Access Compliance Report Public Rights-of-Way (Curb Ramps)

Main Street: AUGUSTA_DR		Cross Street: POES_ST		Location:	SE
ADA ID: RPAT211124145649	Ramp Type: Type 4 - Parallel	Initial Pass/Fail: Fail	Overall Compliance: No	Severity Score:	15

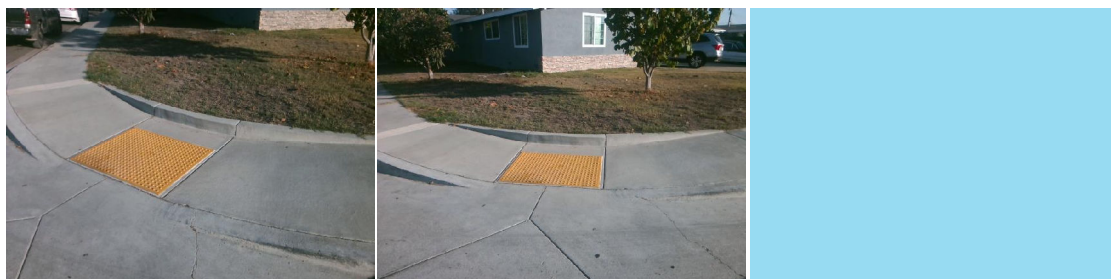
Compliance	Description	Data	Compliance	Description	Data
N/A	Ramp Length LT (in)	84	N/A	Ramp Length RT (in)	85
Yes	Ramp Width LT (in)	56	Yes	Ramp Width RT (in)	56
No	Ramp Run Slope LT (%)	8.5	Yes	Ramp Run Slope RT (%)	7.4
Yes	Ramp Cross Slope LT (%)	0.7	Yes	Ramp Cross Slope RT (%)	0.4
N/A	Landing Present	N/A	N/A	DWS Provided	N/A
N/A	Landing Length (in)	N/A	N/A	DWS Contrast	N/A
N/A	Landing Width (in)	N/A	N/A	DWS Length (in)	N/A
N/A	Landing Run Slope (%)	N/A	N/A	DWS Full Width	N/A
N/A	Landing Cross Slope (%)	N/A		DWS Offset Type	N/A
N/A	Landing Movement Obstructed?	N/A	N/A	DWS Offset Left (in)	N/A
	Landing Movement Type	N/A	N/A	DWS Offset Right (in)	N/A
N/A	Landing Shared	N/A			
N/A	Clear Space	Yes			
N/A	Clear Space To Crosswalk (in)	N/A			
N/A	Marked Crosswalk 1	No	N/A	Marked Crosswalk 2	No
	Crossing 1 Direction	N		Crossing 2 Direction	W
	Marked Crosswalk 1 Width (in)	N/A		Marked Crosswalk 2 Width (in)	N/A

Remove & Replace Curb Ramp With Two New Directional Ramps or Equivalent. Replace Cross Gutter.

R304.3.2, STD 122-2, STD 1115
